SUBJECT: ISSUANCE OF AMENDMENTS - JOSEPH M. FARLEY NUCLEAR PLANT,
UNITS 1 AND 2 (TAC NOS. MA5119 AND MA5120)

Amendment No. 142
License No. NPF-2

Amendment No. 134
License No. NPF-8

SAFETY EVALUATION BY THE OFFICE OF NUCLEAR REACTOR REGULATION
RELATED TO AMENDMENT NO. 142 TO FACILITY OPERATING LICENSE NO. NPF-2
AND AMENDMENT NO. 134 TO FACILITY OPERATING LICENSE NO. NPF-8
SOUTHERN NUCLEAR OPERATING COMPANY, INC., ET AL.
JOSEPH M. FARLEY NUCLEAR PLANT, UNITS 1 AND 2
DOCKET NOS. 50-348 AND 50-364

FIGURE 3.4-1

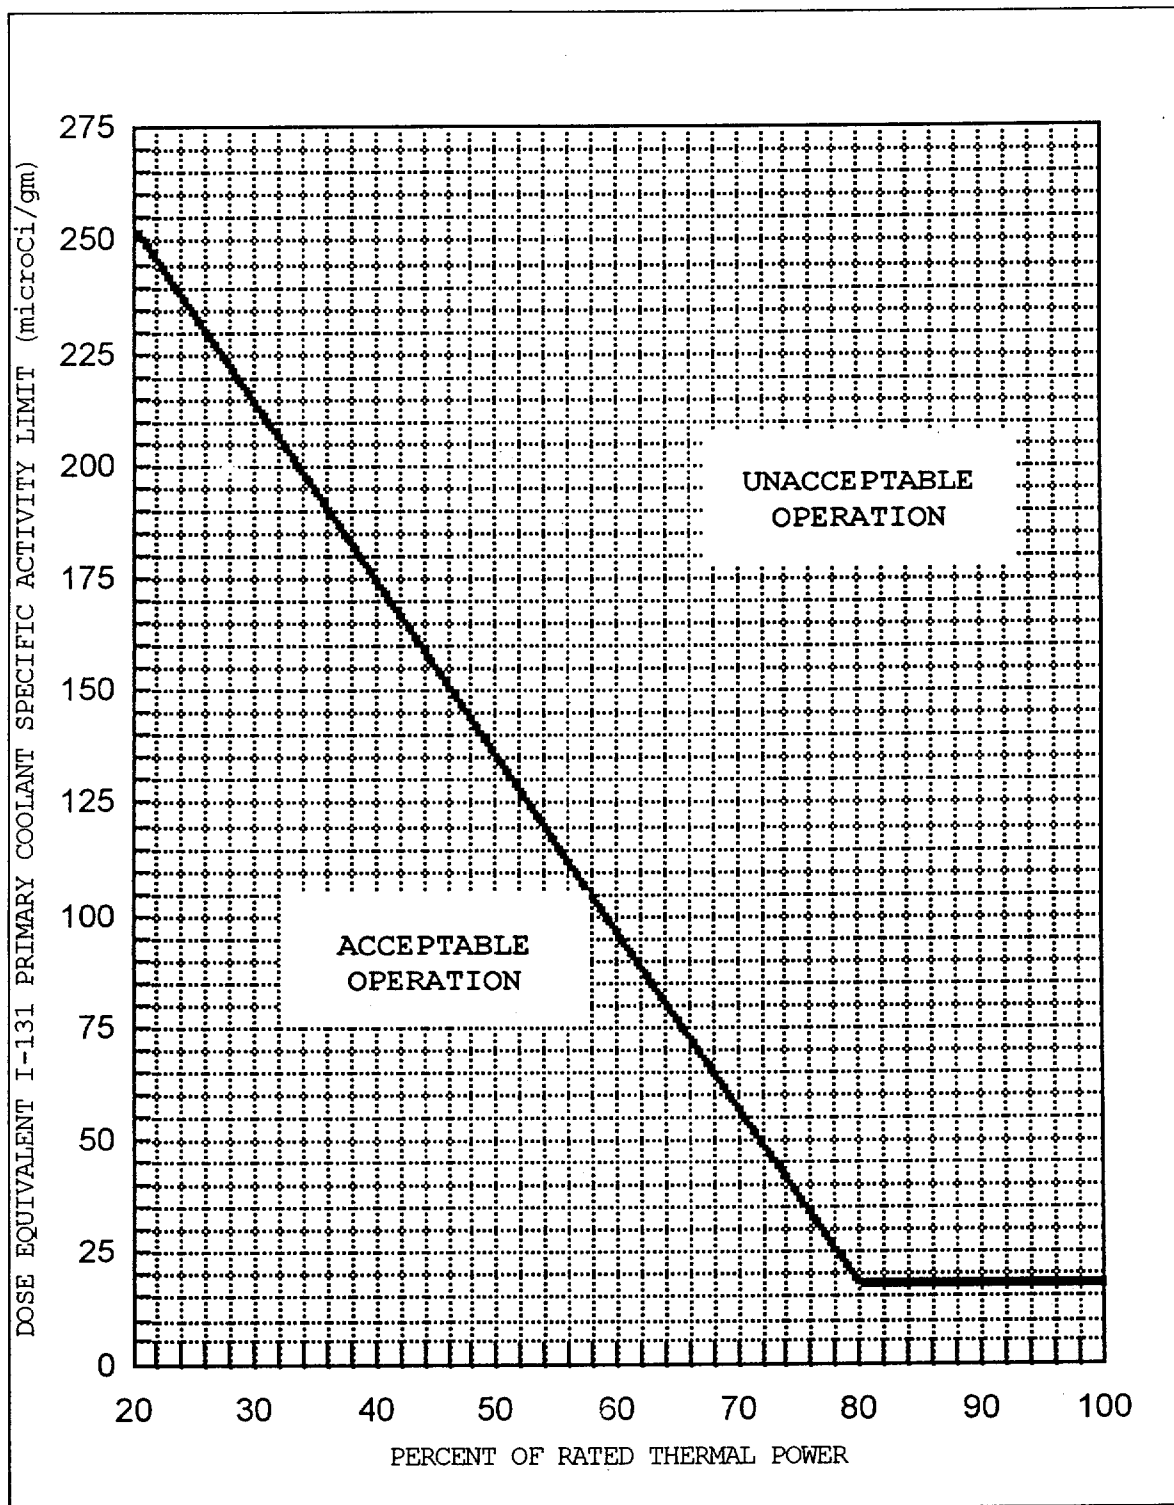
The amendment changes TS 3/4.4.9, "Specific Activity," and the associated bases to increase the limit associated with dose equivalent iodine-131. The steady-state dose equivalent iodine-131 limit would be increased from 0.15 μ Curie/gram to 0.3 μ Curie/gram and the transient limit for 80 percent to 100 percent power provided by Technical Specification Figure 3.4-1 will increase from 9 μ Curie/gram to 18 μ Curie/gram with a corresponding increase in the 0 percent to 80 percent power limits.

- a. With the specific activity of the primary coolant greater than 0.30 microCurie per gram DOSE EQUIVALENT I-131 for more than 48 hours during one continuous time interval or exceeding the limit line shown on Figure 3.4-1, be in at least HOT STANDBY with T_{avg} less than 500°F within 6 hours.
- b. With the specific activity of the primary coolant greater than $100/\bar{E}$ microCurie per gram, be in at least HOT STANDBY with T_{avg} less than 500°F within 6 hours.

The ACTION statement permitting POWER OPERATION to continue for limited time periods with the primary coolant's specific activity greater than 0.30 microCuries/gram DOSE EQUIVALENT I-131, but within the allowable limit shown on Figure 3.4-1, accommodates possible iodine spiking phenomenon which may occur following changes in THERMAL POWER.

FIGURE 3.4-1

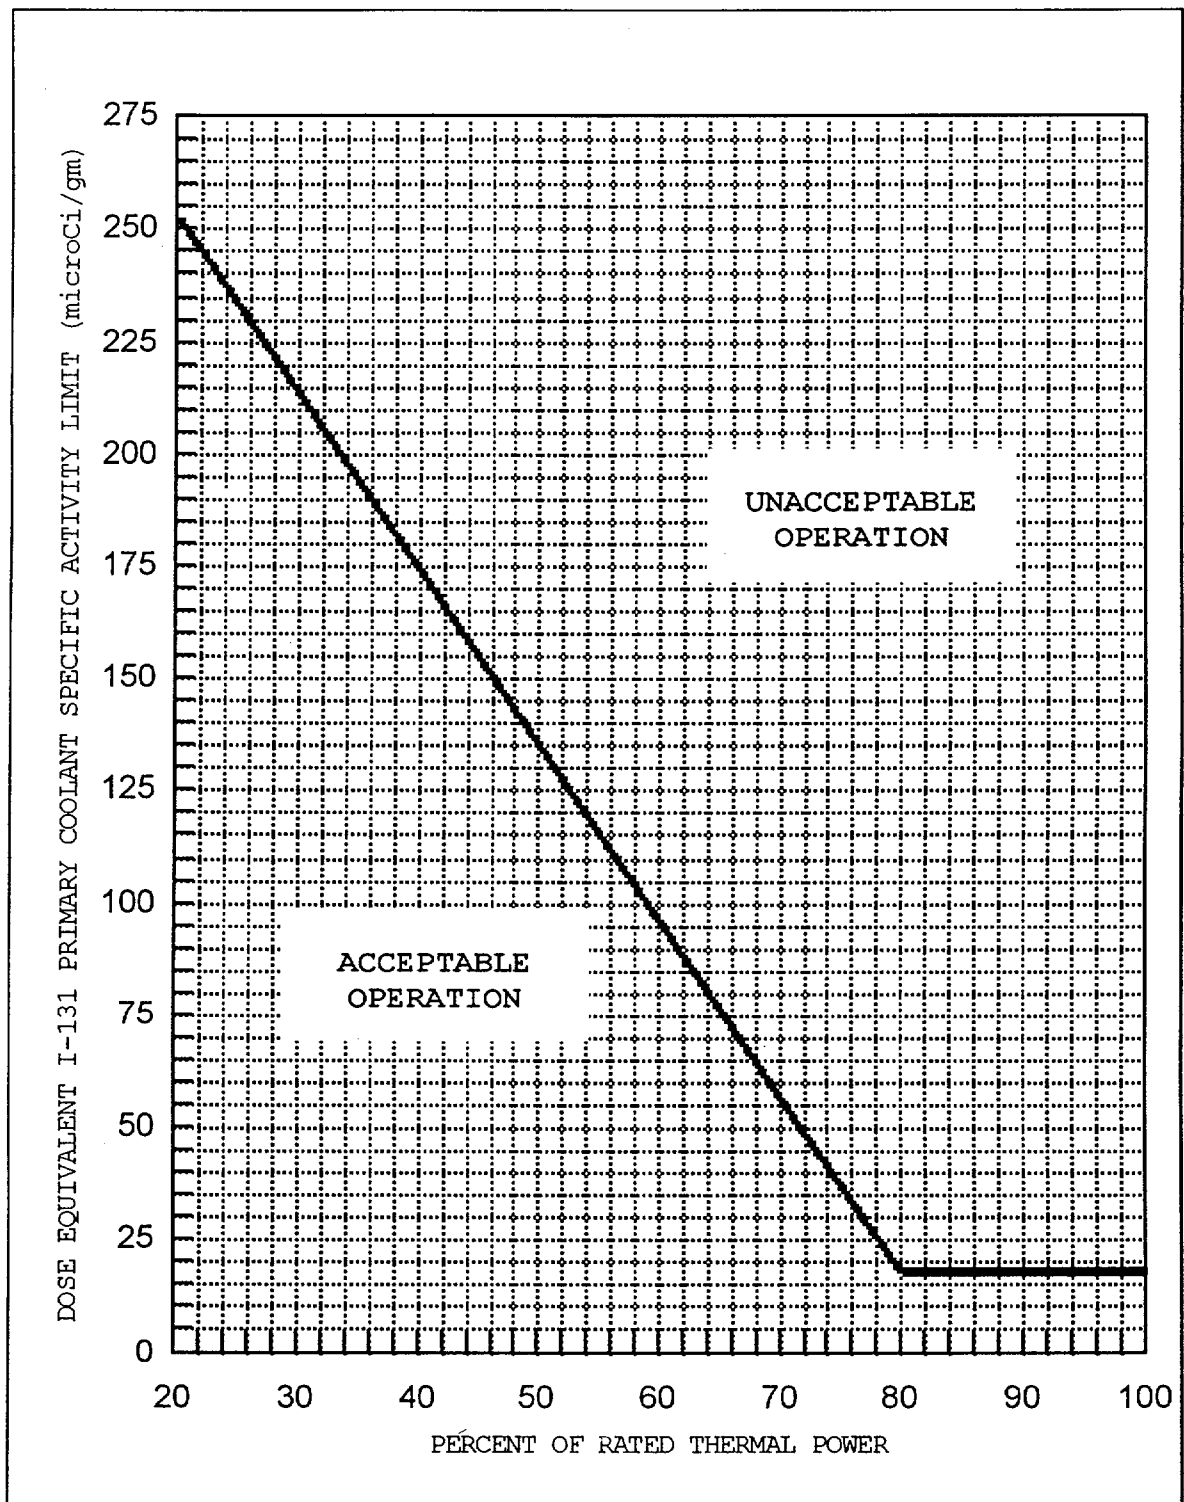
The amendment changes TS 3/4.4.9, "Specific Activity," and the associated bases to increase the limit associated with dose equivalent iodine-131. The steady-state dose equivalent iodine-131 limit would be increased from 0.15 μ Curie/gram to 0.3 μ Curie/gram and the transient limit for 80 percent to 100 percent power provided by Technical Specification Figure 3.4-1 will increase from 9 μ Curie/gram to 18 μ Curie/gram with a corresponding increase in the 0 percent to 80 percent power limits.

- a. With the specific activity of the primary coolant greater than 0.30 microCurie per gram DOSE EQUIVALENT I-131 for more than 48 hours during one continuous time interval or exceeding the limit shown on Figure 3.4-1, be in at least HOT STANDBY with T_{avg} less than 500°F within 6 hours.
- b. With the specific activity of the primary coolant greater than $100/\bar{E}$ microCurie per gram, be in at least HOT STANDBY with T_{avg} less than 500°F within 6 hours.

The ACTION statement permitting POWER OPERATION to continue for limited time periods with the primary coolant's specific activity greater than 0.30 microCuries/gram DOSE EQUIVALENT I-131, but within the allowable limit shown on Figure 3.4-1, accommodates possible iodine spiking phenomenon which may occur following changes in THERMAL POWER.
